Service Bulletin

PRELIMINARY INFORMATION

Subject: Information on Front Engine Mount Service Recommendation

Models: 2008-2015 Buick Enclave
2009-2015 Chevrolet Traverse
2007-2015 GMC Acadia
2007-2010 Saturn OUTLOOK

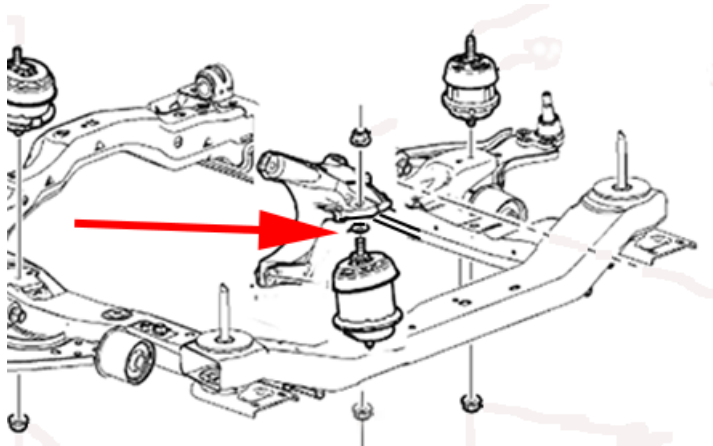
During normal operation of the vehicle where frequent hot ambient temperatures are experienced, the heat generated from the powertrain may be transferred into the front engine mount from the mount bracket and may weaken the rubber material in the mount.

In addition to replacing the front engine mount nuts, General Motors recommends the installation of a newly released washer, P/N 22925178, underneath the front engine mount bracket, on top of the engine mount as illustrated above. This service recommendation will help prevent the weakening of the rubber material in the mount by reducing the transfer of the excessive heat.
